Application Referral Environmental Development Planner - Response

From:	Rowan Moore Environmental Development Planner 22 May 2018
Recommendation:	Proposal is acceptable subject to conditions.
Date Completed:	
Address:	6 BROUGHTON AVENUE, MOUNT NELSON 8 BROUGHTON AVENUE, MOUNT NELSON
Proposal:	Multiple Dwellings
Application No:	PLN-18-178
Assessment Officer:	Michaela Nolan,

Figure 1: Trees on the site required to be retained under Tree Retention Plan (numbered dots)

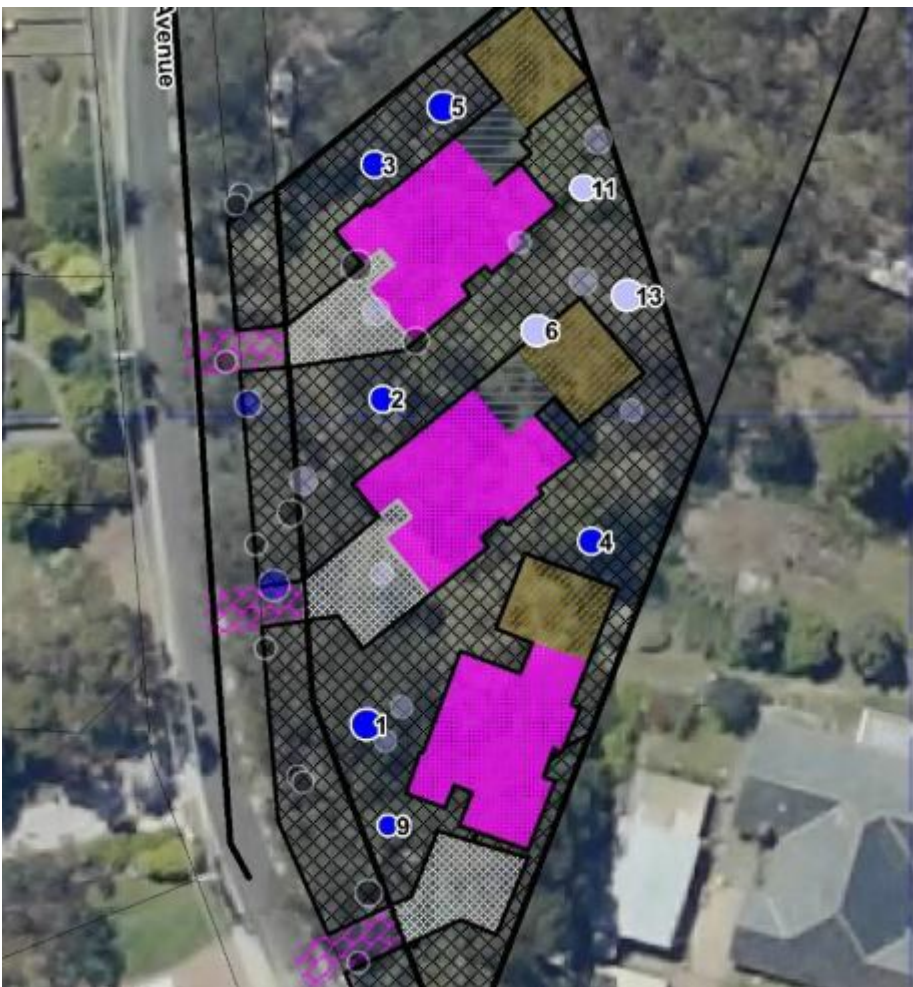
Three of the trees required to be retained under the tree retention plan (2, 3 and 5) are located close to proposed Unit 1 or its driveway (refer to Figure 1 below). An additional tree on the TRP (tree 6) is located close to the building footprint of Unit 2. These were identified as being of moderate priority biodiversity significance under Table E.10.1 of the Code.

A statement from an ecological consultant, supported by an arborist's assessment, was submitted with the application discussing potential impacts upon these trees as a result of root damage. With regard to tree 6, the statement indicates that the incorrect tree has been shown on the plan and that the moderate biodiversity value tree from the original assessment will not be impacted by the current proposal. With regard to trees 2, 3 and 5 (labelled as trees 4, 1 and 2 on the site plan and arborist's report), the statement indicates that these trees will not be unduly affected by the proposed development, based on the arborist's assessment and subject to the arborist's recommendations being implemented.

It appears that the current proposal places the northern most dwelling within proximity to tree 1 and 2. Given that there has already been significant soil disruption and compaction, I recommend that works go no closer than 4.5m from the edge of the trunk of tree 1, and 5m from tree 2. To provide adequate water and oxygen for both these trees, I would also recommend that the wall closest to the trunks is built on a post footing, opposed to a traditional strip footing.

If the building cannot be offset these distances, I suggest that an absolute minimum of 3m is achieved from each tree. If this occurs, subsurface irrigation and mulch should be placed in the tree protection zones and beneath the dwelling. The irrigation should be utilised during development and extended dry periods. The subsurface system should be installed according to manufacturer's recommendations¹.

The submitted plans show a minimum offset of 3.0m from Unit 1. Subsurface irrigation and mulching will therefore be required as well as post footings for the northern wall of Unit 1 to protect these trees.

With regard to tree number 2 on the tree retention plan (labelled tree 4 on the site plan and in the arborist's report), the arborist's report states the following:

Tree 4 may be impacted through the development of the driveway. It appears that there will need to be some fill placed so the cross over will be at a suitable grade to meet the driveway. To limit the impact on this tree I suggest that no fill is placed within 4.5m of this tree and if the existing soil level is to become carpark, the medium covering this is a permeable surface which will allow water and oxygen to reach the roots.

No fill over tree protection zone for this tree is evident in the submitted drawings and the area of driveway is shown as being as permeable surface.

- 3. show the tree protection zones (TPZs) where works are to be excluded for the trees specified for retention in the Tree Retention Plan included in Part 5 Agreement E72102, except that the incorrectly identified tree noted in the letter from North Barker dated 30 January 2018 should be corrected;**

- 6. show the area where no filling is to occur and permeable surfacing must be used under tree 4 shown on Site Plan 01;**
- 7. show the area where subsurface irrigation is to be installed and where mulch is to be applied under trees 1 and 2 shown on Site Plan 01;**

- 8. include details of the subsurface irrigation and mulching requirements for trees 1 and 2 shown on Site Plan 01; and**
- 9. specify the irrigation regime to be implemented during construction works.**

- 1. correct the location of the significant tree referred to in the letter from North Barker dated 30 January 2018; and**
- 2. provide details of ongoing subsurface irrigation and mulching requirements for trees 1 and 2 shown on Site Plan 01 (and marked as trees 3 and 5 in the Tree Retention Plan) as recommended in the letter from Alister Hodgman dated 24 January 2018.**
